## 25/30/40/50/60 FourStroke Upper Motor Mount Bolt Torque Specification

Models Covered	Part Number
25 BigFoot FourStroke	854785R2
30/40 FourStroke EFI	883064R02
40 FourStroke 3 Cyl	899974
50/60, 40/50/60 BigFoot, 40 Jet EFI FourStroke 4 Cyl.	866917

31593

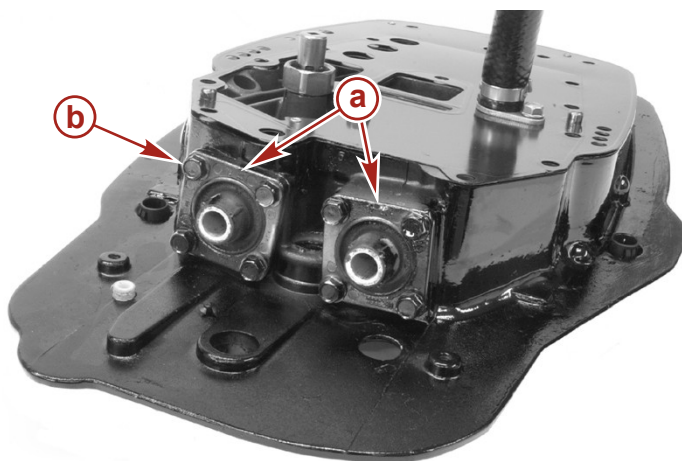
Mercury Marine has updated the torque specification for the upper motor mount bolts. The new values need to be reflected in the above service manuals. Use these revised specifications when torquing the upper motor mount bolts on the above mentioned models.

**NOTE:** If service procedures require removal of the upper motor mount bolts, replace the bolts prior to reassembly. Failure to replace the bolts may result in a reduced clamp load between the upper motor mount and the adaptor plate.

- a - Upper mount (2)
- b - Bolt (M6 x 20) (4 per upper mount)

Description	Nm	lb-in.	lb-ft
Upper mount bolts (M6 x 20)	12	106	-
